## INDIANA DEPARTMENT OF TRANSPORTATION

# FINAL DRAFT MINUTES

## September 21, 2017 Standards Committee Meeting

RE: Minutes from the September 21, 2017 Standards Committee Meeting

PROPOSED NEW RPD 801-T-2XXd NEXT LEVEL ROADS SIGN (REVISED DRAFT)

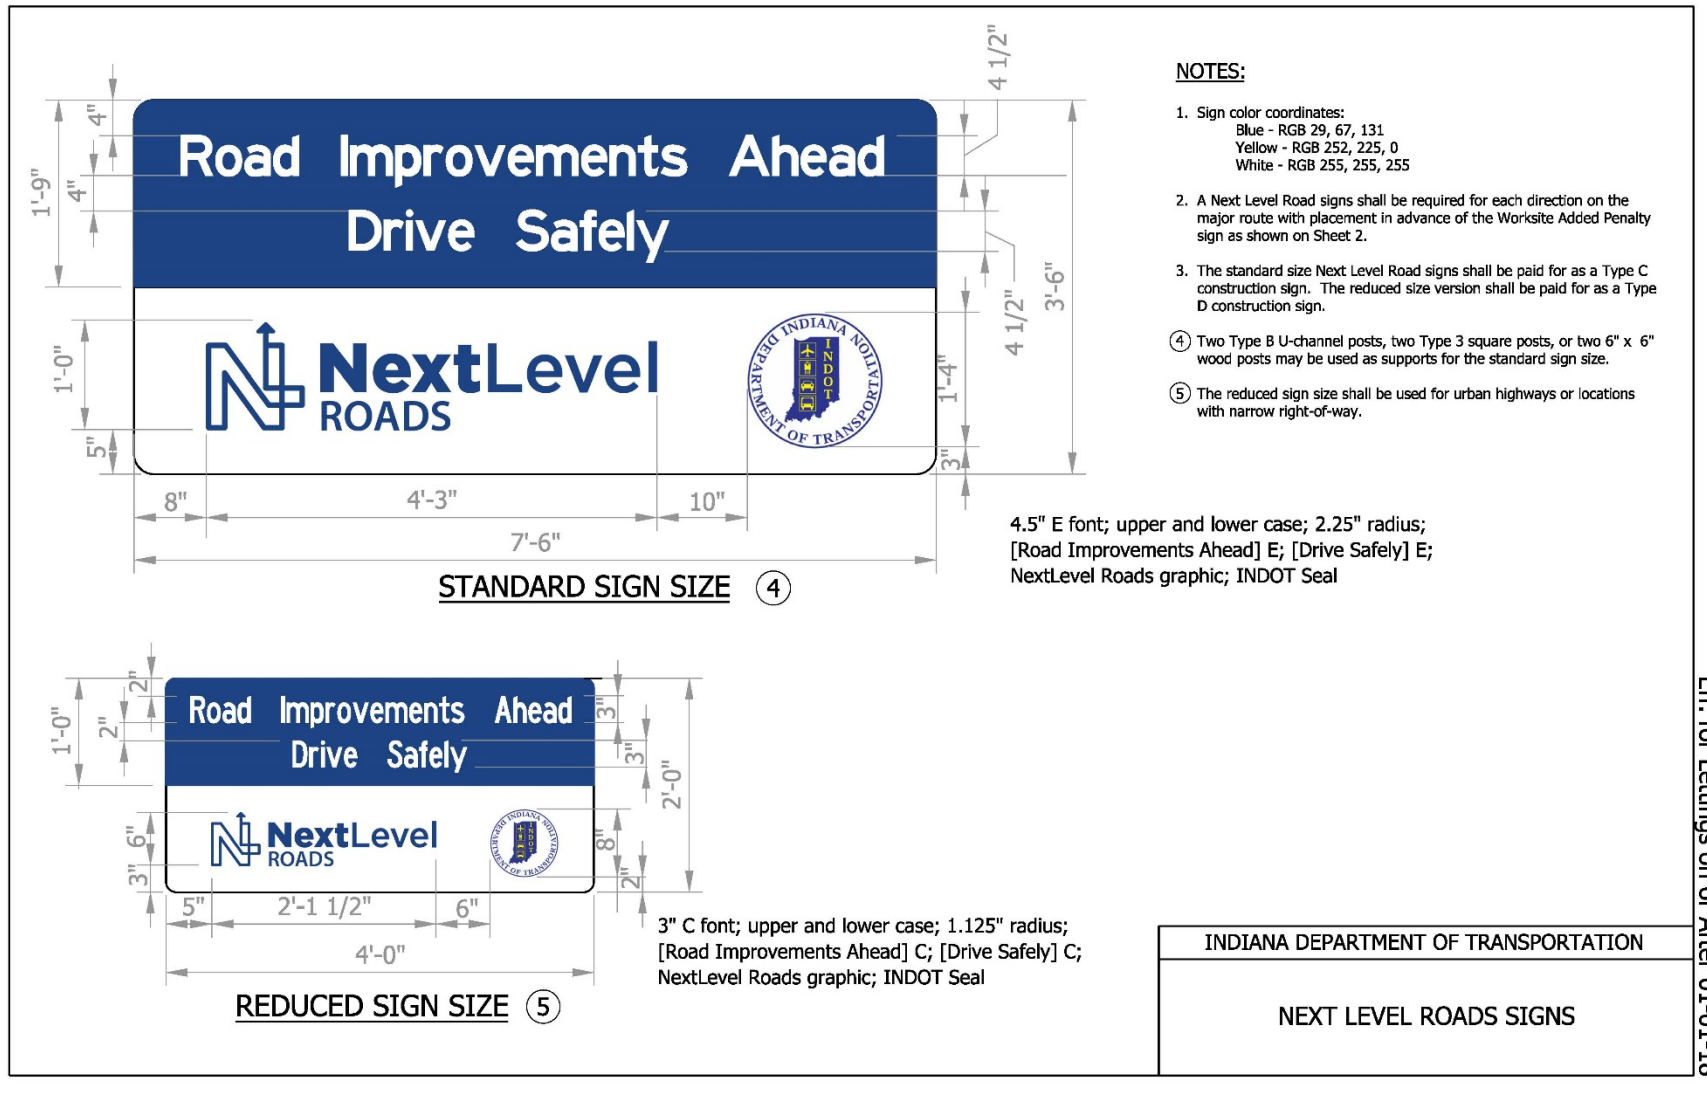
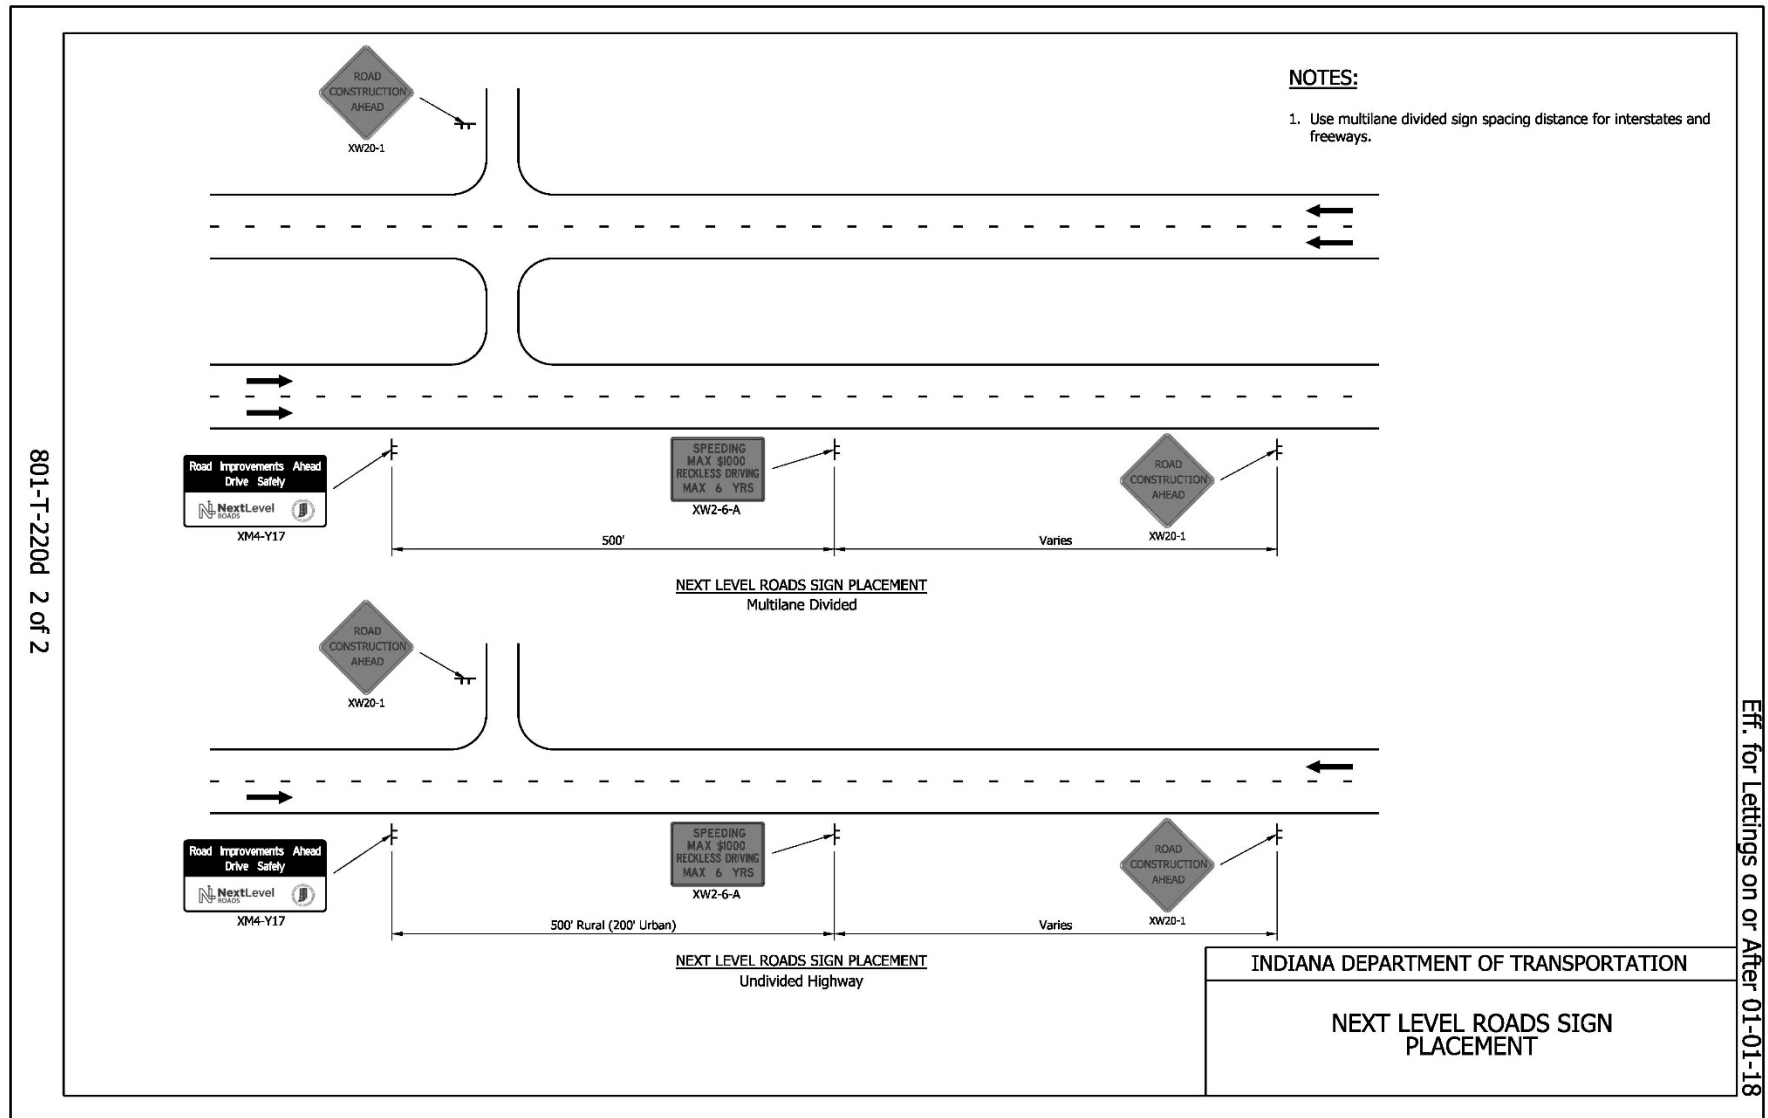
This item was introduced and presented by Mr. Boruff who explained that the Governor's Office has requested information signs to identify Next Level Roads projects. Mr. Boruff proposed to create a recurring plan detail with sign shop drawings and typical placement locations. The sign design was developed by the Department's Central Office and is as shown above.

Mr. Osborn expressed concern over the type of sign this will be and if it can be properly manufactured. Mr. Bruno offered solutions to those concerns, and will provide revisions accordingly.

Mr. Boruff revised his motion.
